SUBMISSION TO THE COMMISSION FOR REGULATION OF UTILITIES

What It Takes to Cost Both Sides

A response to CRU202704 — Grid Code Modification MPID 345 and the Compliance and Derogation Framework. What a proportionality assessment requires, and which of its inputs the public record does not currently contain.

Submitted 14 July 2026 · CRU reference CRU202704

EXHIBIT 1 — The case for urgency, on EirGrid's own data

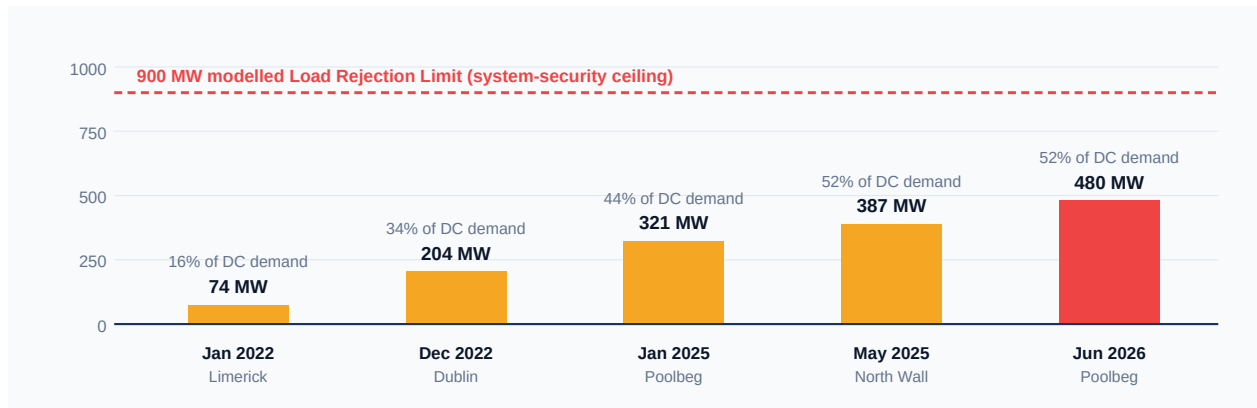
We support TNEI's overarching recommendation: approve MPID 345 as a matter of urgency. The recorded events escalate, the most recent is the largest, and the load-rejection limit has been reached.

Bars: observed data-centre demand reduction following transmission faults, 2022–2026. All five events were single-phase. **Line:** the separate 900 MW modelled load-rejection limit — the system-security ceiling, not an observed value. The two are different measures. EirGrid's modelling indicates approximately 90% of data-centre demand could reduce for a credible three-phase fault, and reports that aggregate data-centre demand of approximately 1,000 MW was recorded in June 2026, at which level the ceiling is engaged. Sources: CRU202704 Table 1 and §1.4; CRU202705 §3.3–3.4.
